Subject: FW: Courtyard Marriott

Attachments: Courtyard by Marriot-Hyannis A1.1 Revision 6-15-2017.pdf; Courtyard by Marriot-Hyannis A2.1

Alterations & Additions Courtyard by Marriot

707 Iyannough Rd Hyannis, MA

WEST ELEVATION

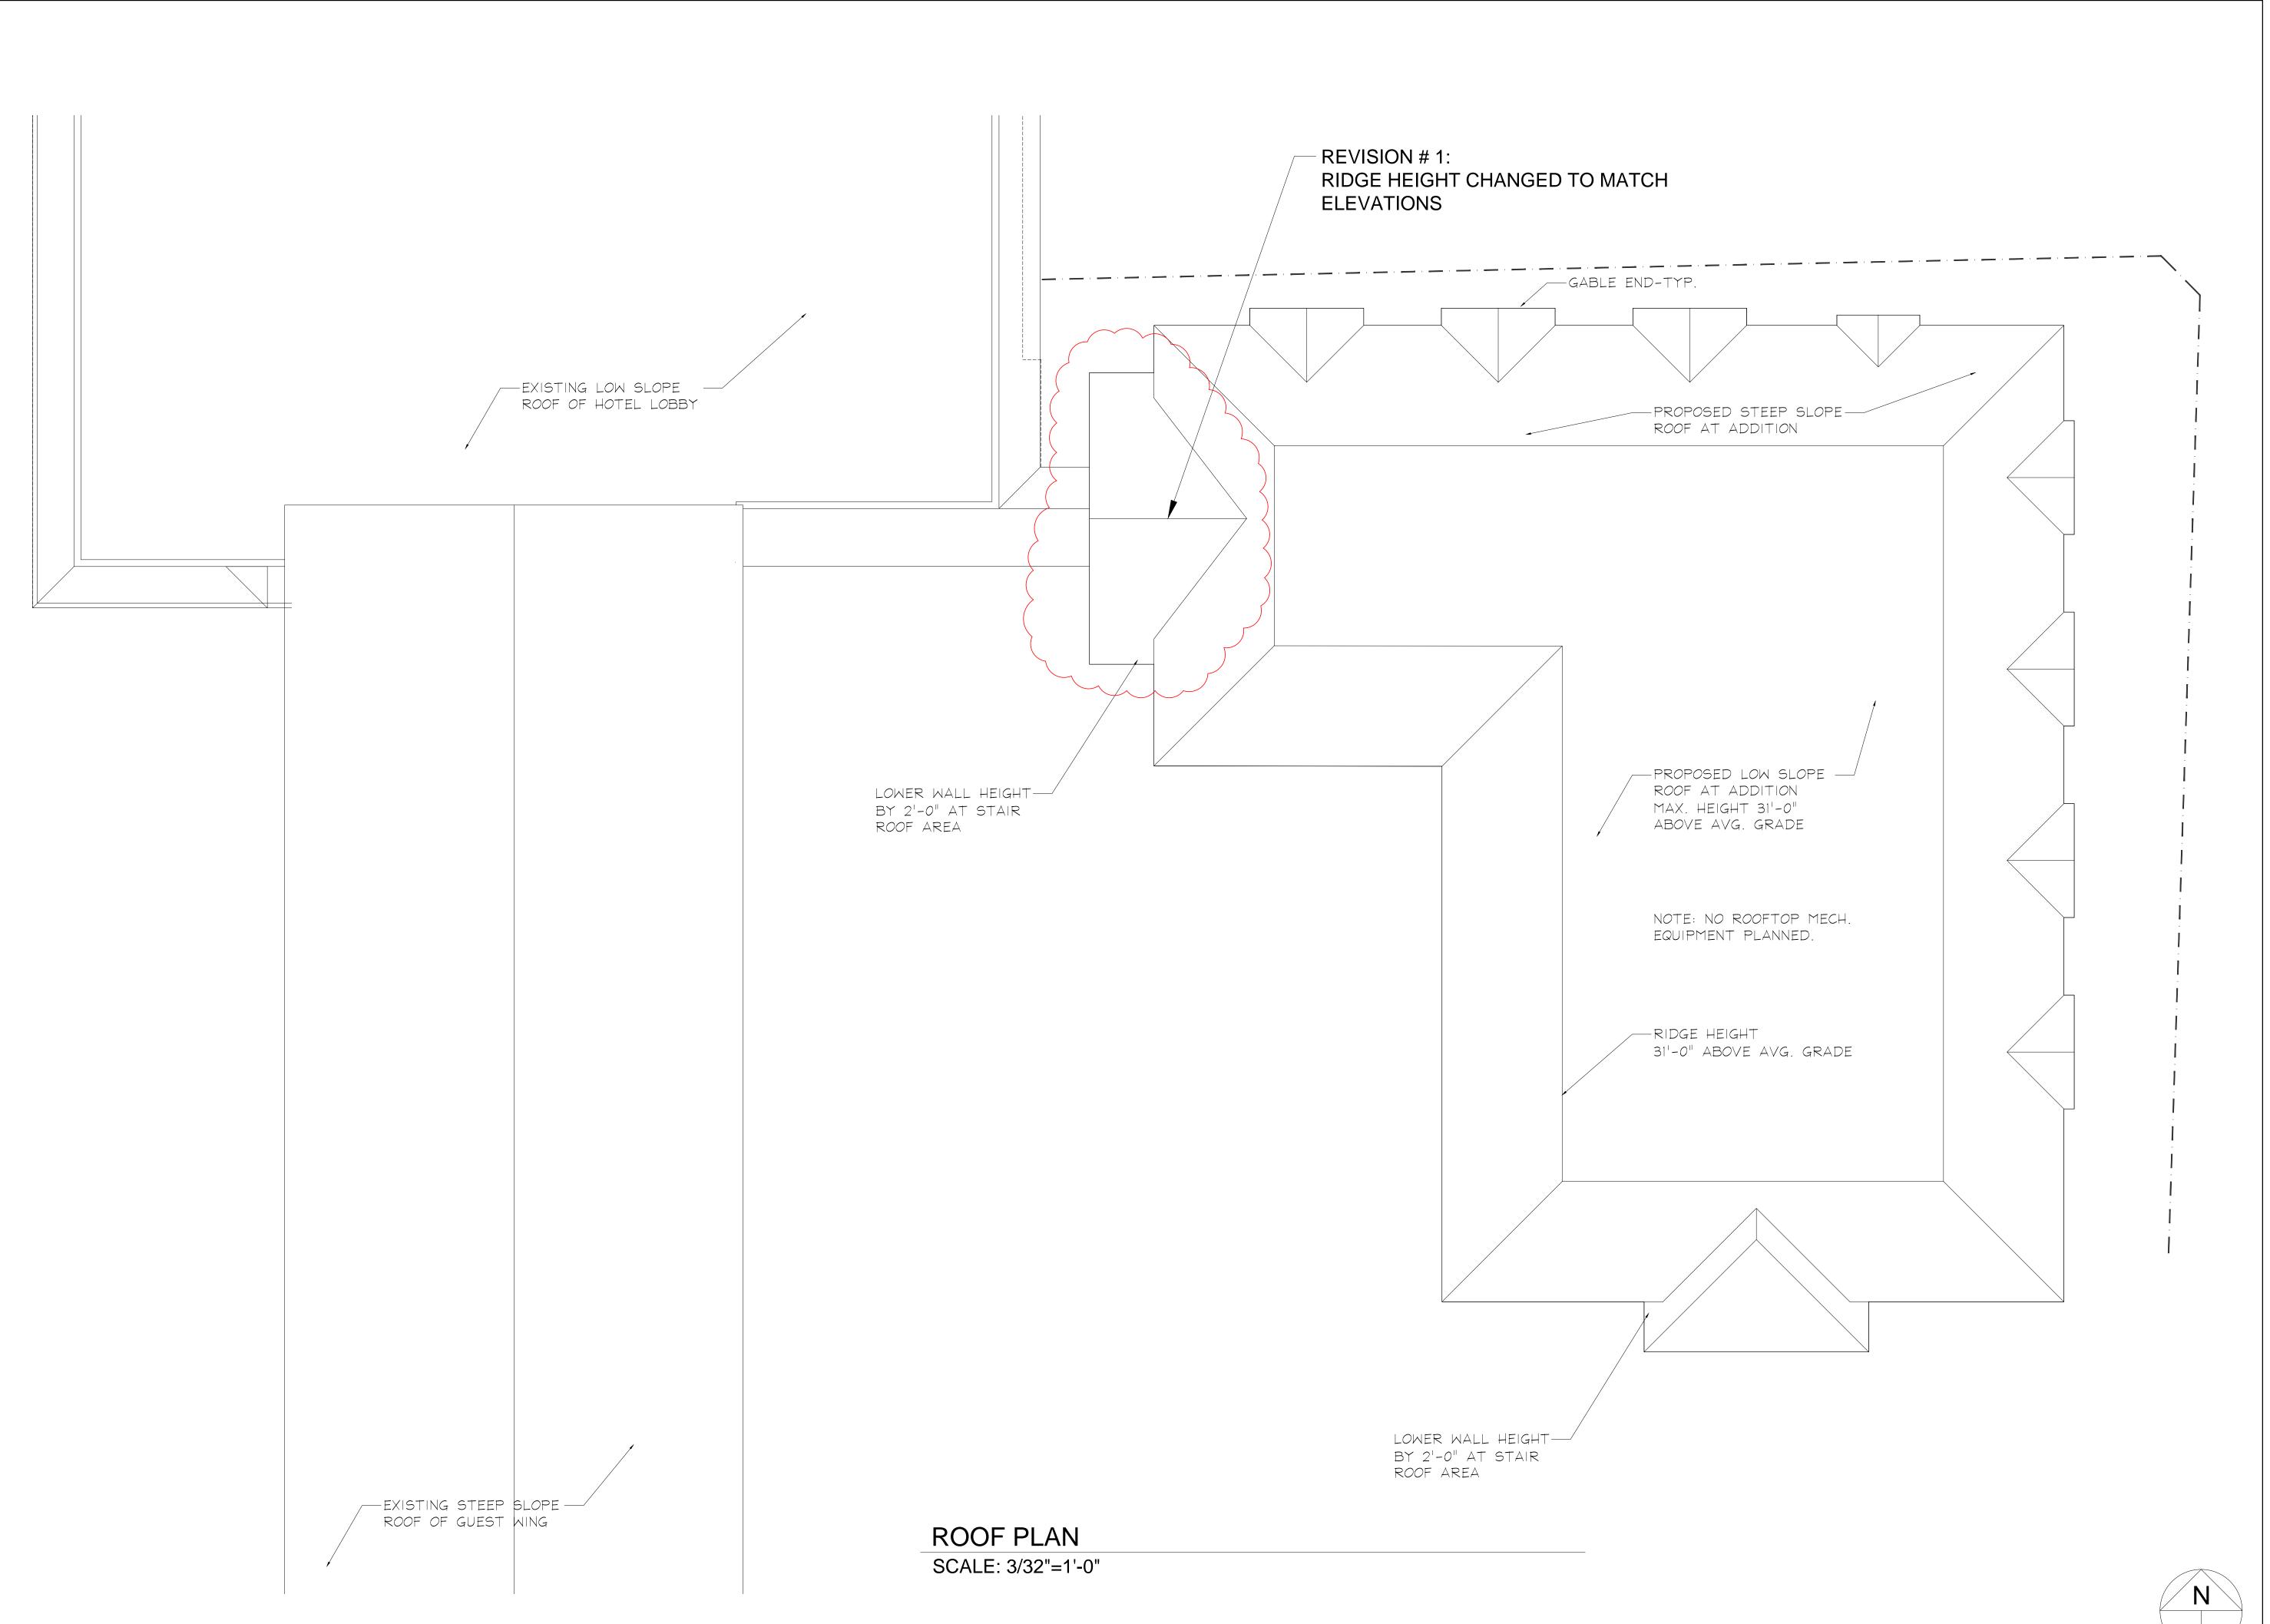
The proposed building has a building footprint of approximately 15,100 square feet. It is set well back from Route 132 and will be partially screened by other development, but will still be visible due to its size and the presence of open parking lots between it and the roadway. The applicant has worked with Commission staff to add variation to the building facades, to reduce the roof and eave height in some areas, and to use exterior building materials that will appear similar to traditional building materials. All of these features will help to address visual impacts from the project. There are, however, still some inconsistencies in the building plans that need to be corrected. Some of the facade elevations do not reflect the reduced ridge height near the one story connector to the existing building.

Thank you for forwarding these comments. Attached are revised architectural drawings that address the noted plan inconsistencies regarding the one-story connection to the existing hotel building.

REVISION # 1: RIDGE HEIGHT CHANGED TO MATCH NORTH & SOUTH ELEVATIONS
